ORIGINATION FORM

Proposed Revisions to a Standard Plans Index
(Please provide all information — Incomplete forms will be returned)

Index Number: 521-660
Sheet Number (s): Sheets 1-4 of 4
Index Title: Light Pole Pedestal - Bridge

An option was included to allow for slip forming of the traffic barrier at the pedestal location. A gap was included between the barrier and pedestal to facilitate this.

TYPICAL SECTION AT LIGHT POLE PEDESTAL
WITH RAISED SIDEWALK

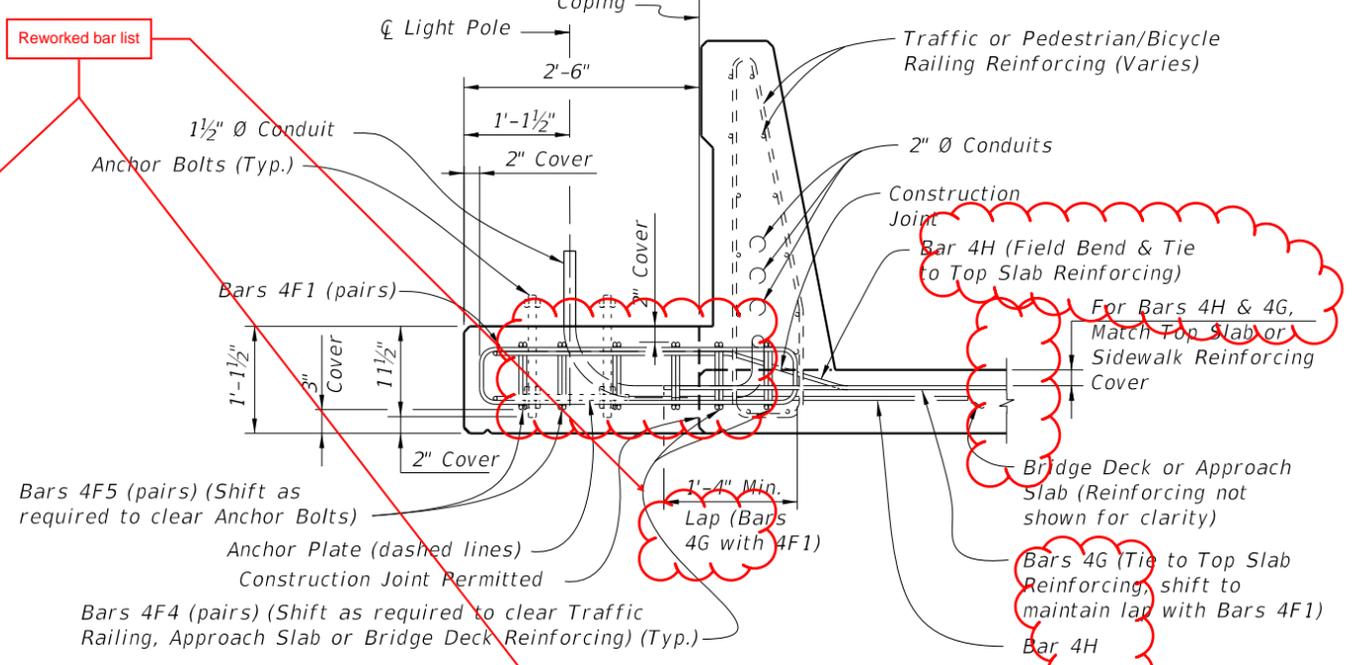
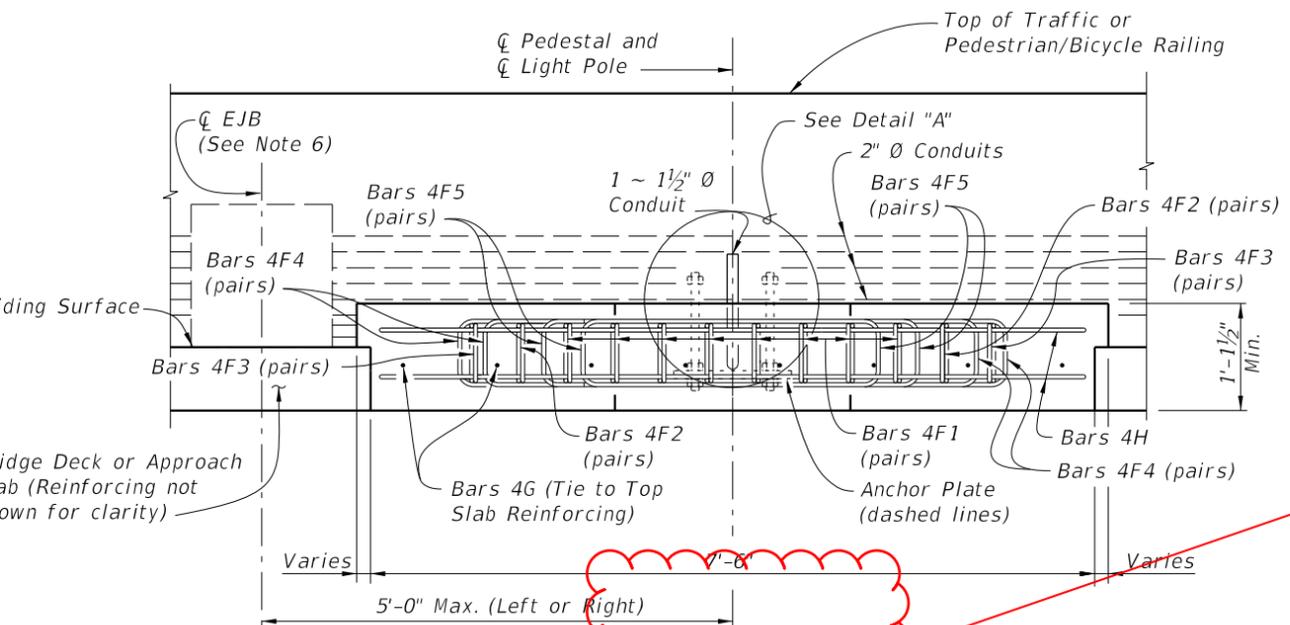
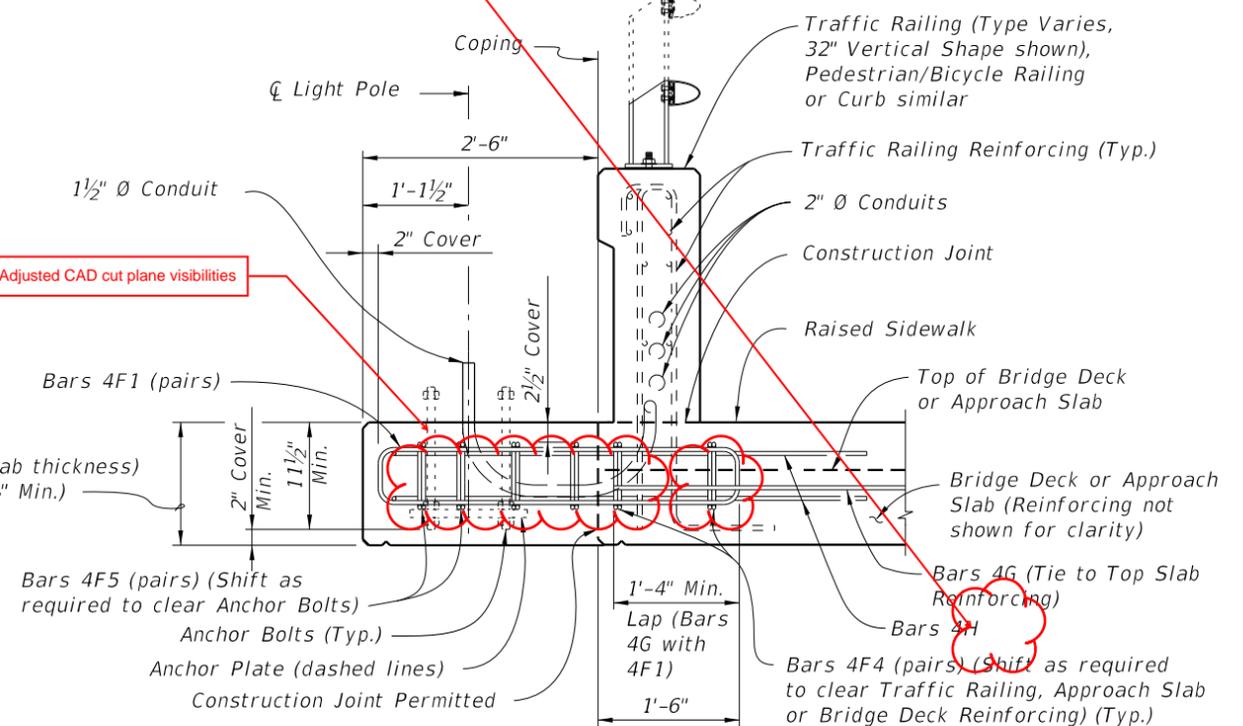
Added clarifying language

CONVENTIONAL REINFORCING STEEL BENDING DIAGRAMS

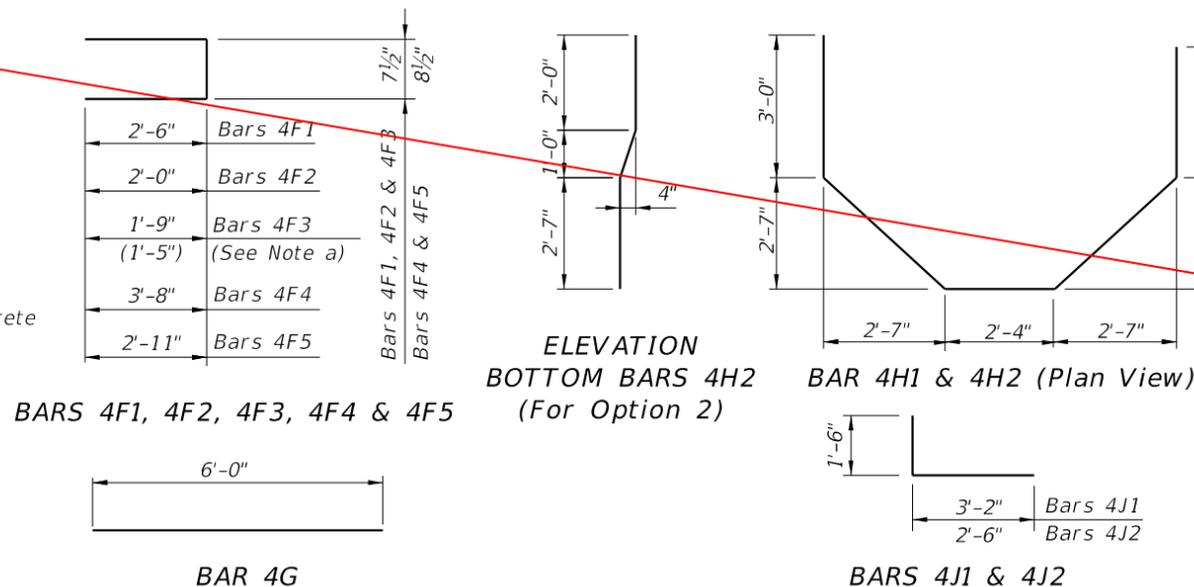
Reworked bar list to fit in new option

BILL OF REINFORCING STEEL				
MARK	SIZE	NO. REQD.	LENGTH	NOTES
F1	4	16	5'-8"	c
F2	4	4	4'-8"	c
F3	4	4	4'-2" (3'-6")	a, c
F4	4	8 (6)	8'-3"	b, c
F5	4	4	6'-7"	c
G	4	8	6'-0"	-
H	4	2	15'-8"	-
J1	4	8	4'-8"	d
J2	4	12	4'-0"	d

DETAIL "A"

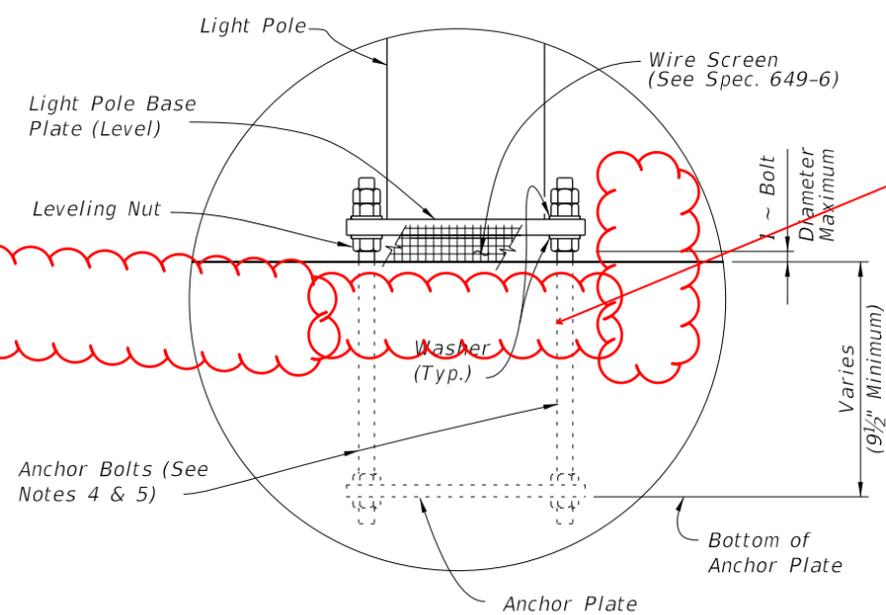
Added anchor nut for bottom of pedestal anchor breakout

OPTION 3 - PLAN VIEW WITH GAP BETWEEN BARRIER AND PEDESTAL TO ALLOW SLIP FORMING

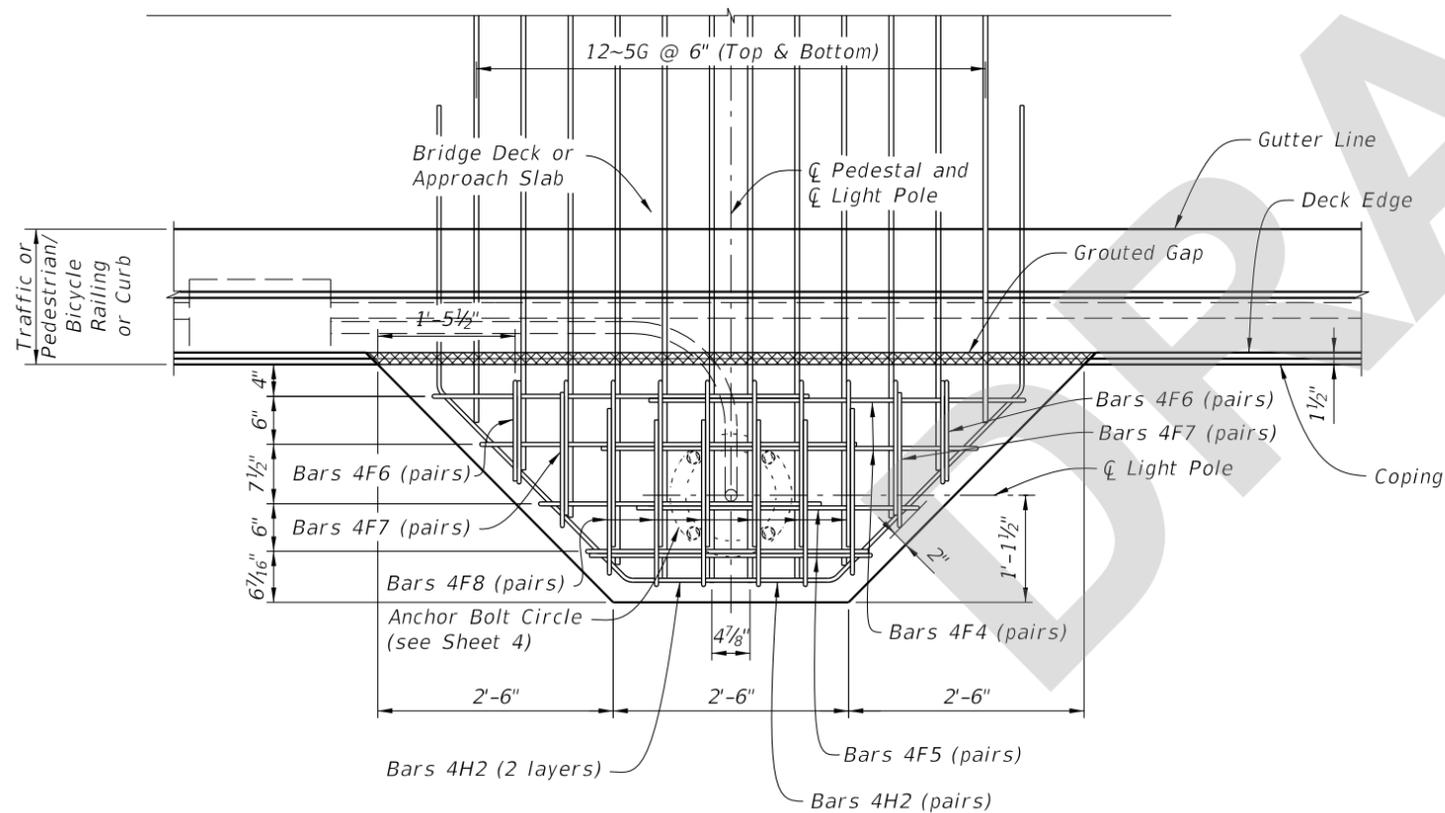
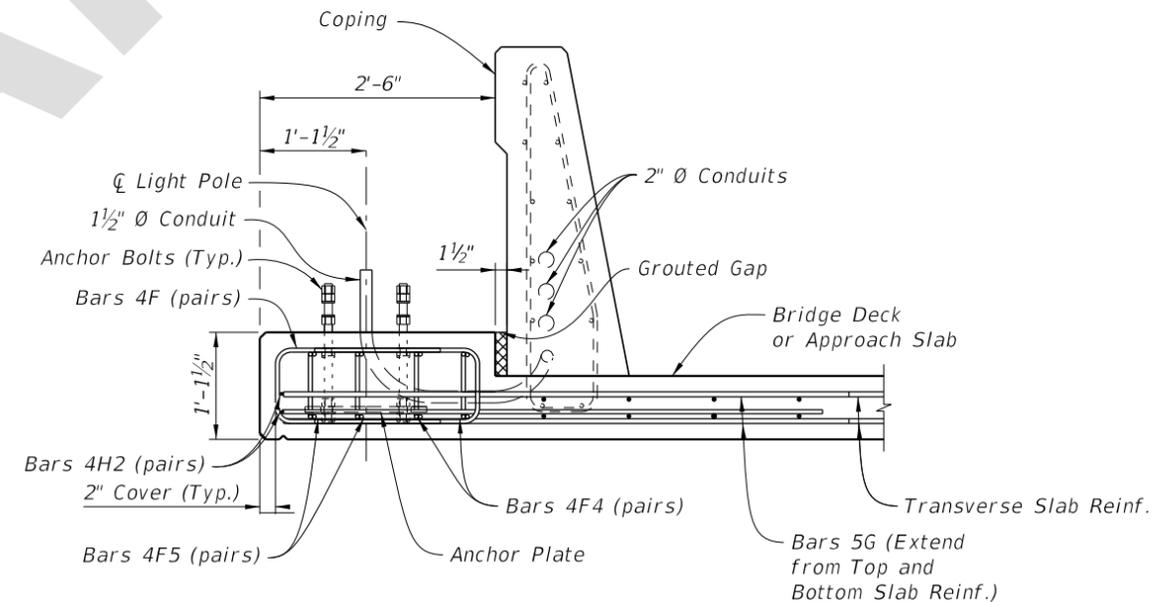
Contractor request in order to save time and materials required to form barrier separately at light pedestal locations.

OPTION 3 - TYPICAL SECTION AT LIGHT POLE PEDESTAL WITH GAP BETWEEN BARRIER AND PEDESTAL TO ALLOW SLIP FORMING
